South Texas Project  
Units 3 and 4  
Docket Nos. 52-012 and 52-013  
Revised Response to Request for Additional Information

**RAI 03.08.04-18, Revision 1, Supplement 1****QUESTION:****Follow-up to Question 03.08.04-2 (RAI 2964)**

### **Description of Changes to the Radwaste Building General Arrangement Drawings**

Figure 9.4-10 - Radwaste Building HVAC P&amp;ID (Sheet 1 of 3)

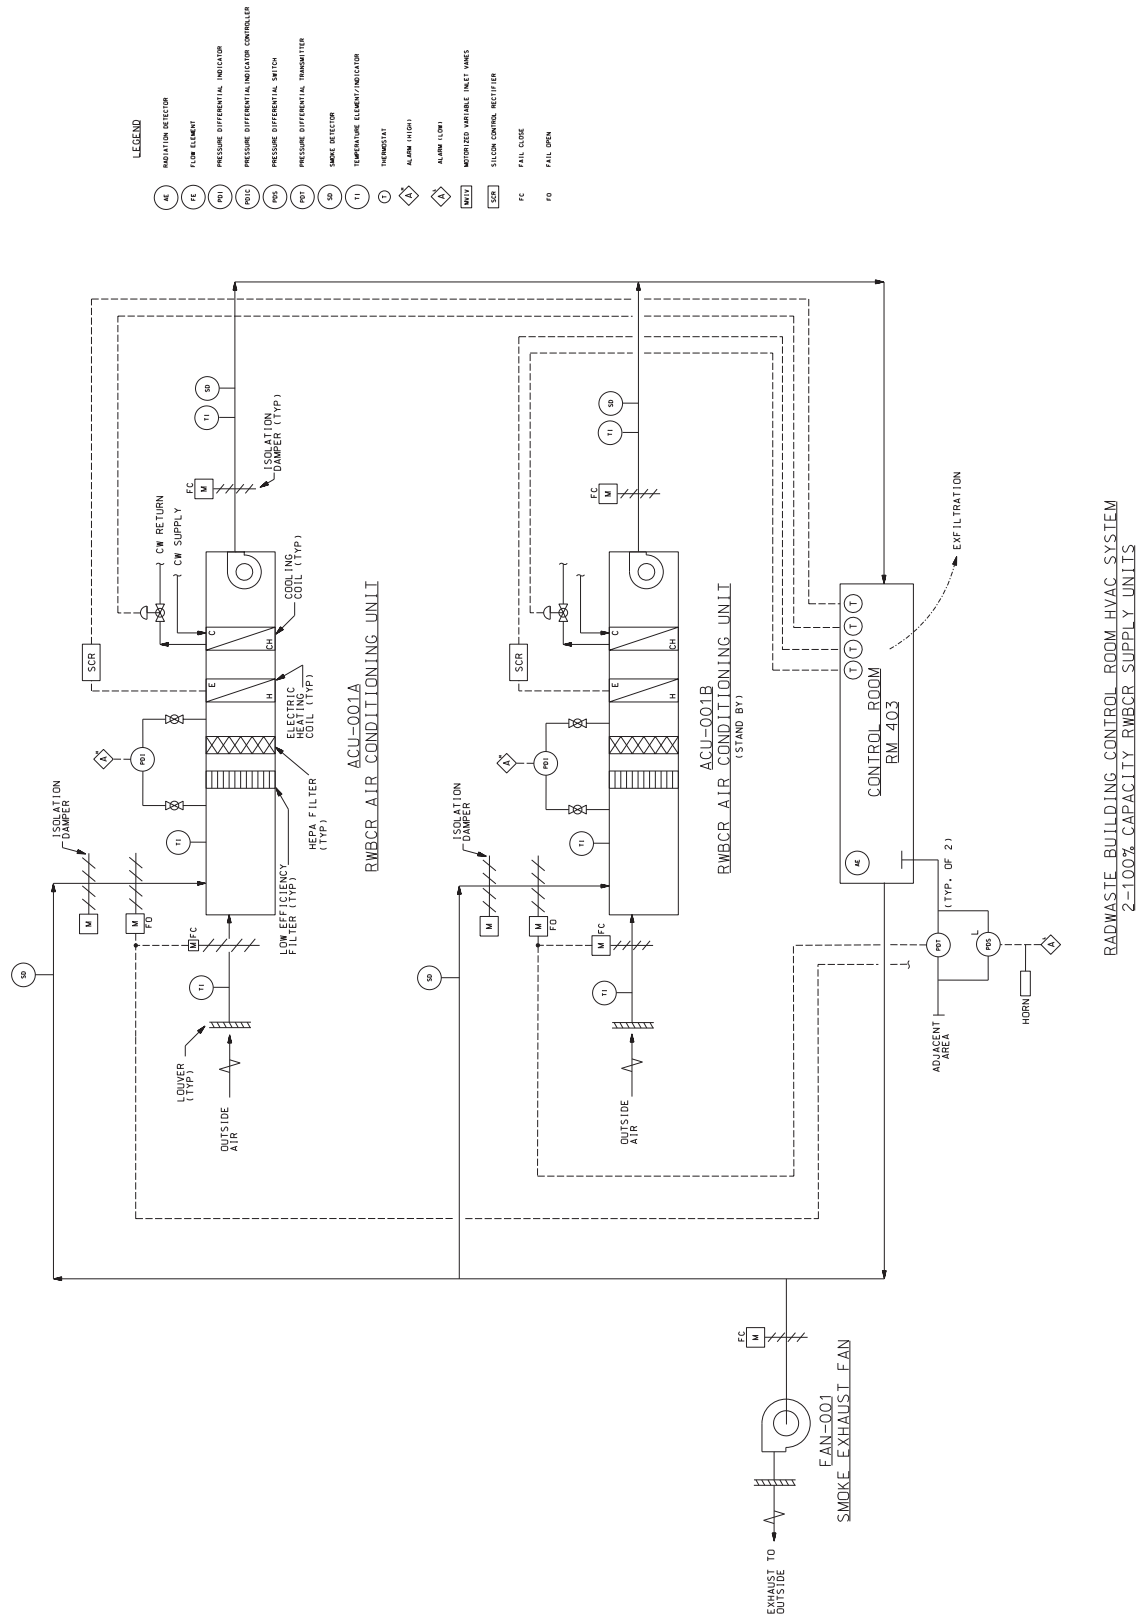
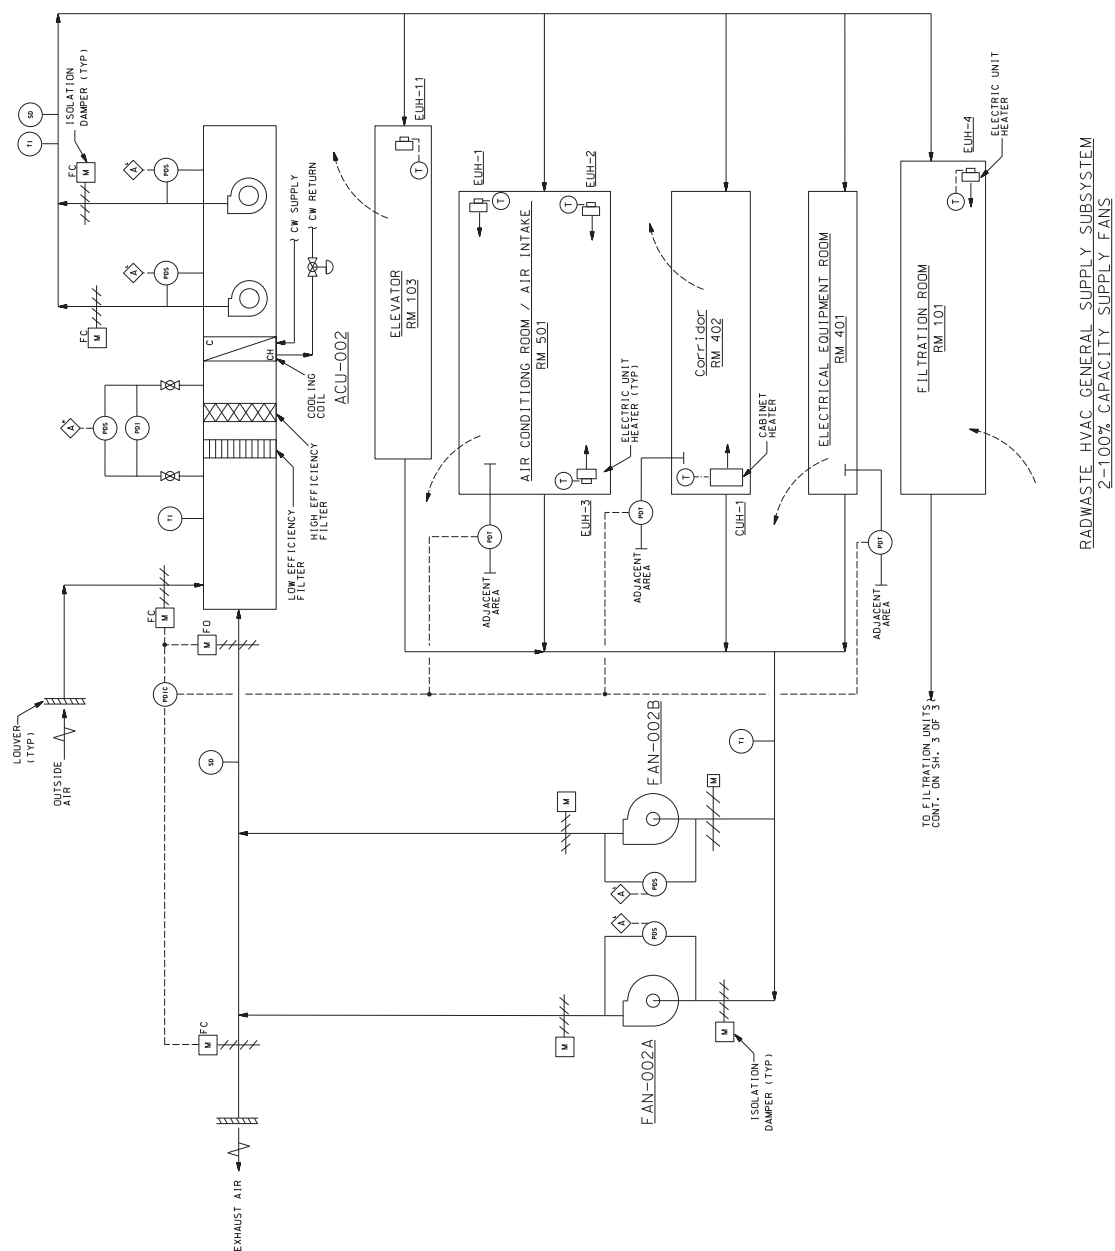
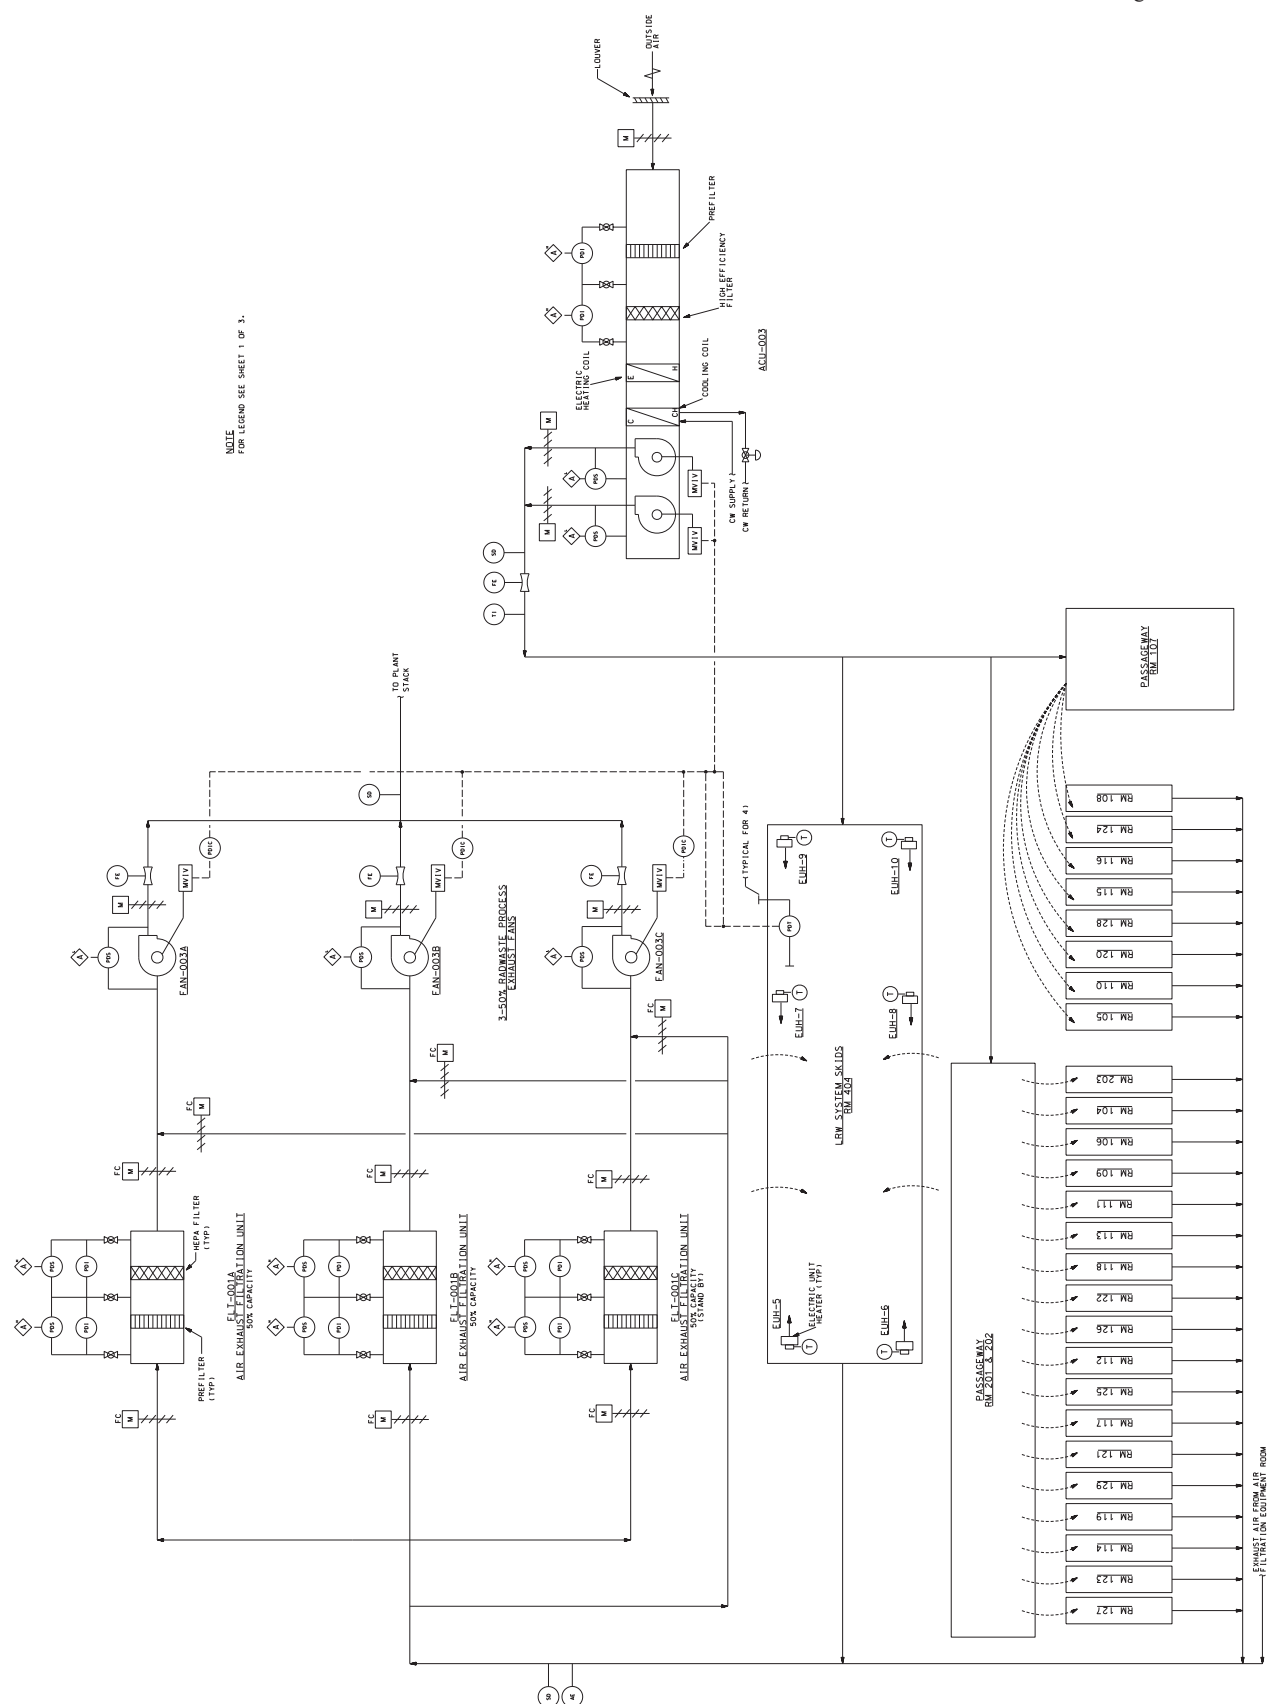
The room numbers and room descriptions for several of the rooms shown on this figure (e.g., Control Room, Electrical Equipment Room, etc.) have been changed to match the room numbers and descriptions shown on the RWB GA figures. These are administrative changes which do not affect the operation or function of the equipment or facility.
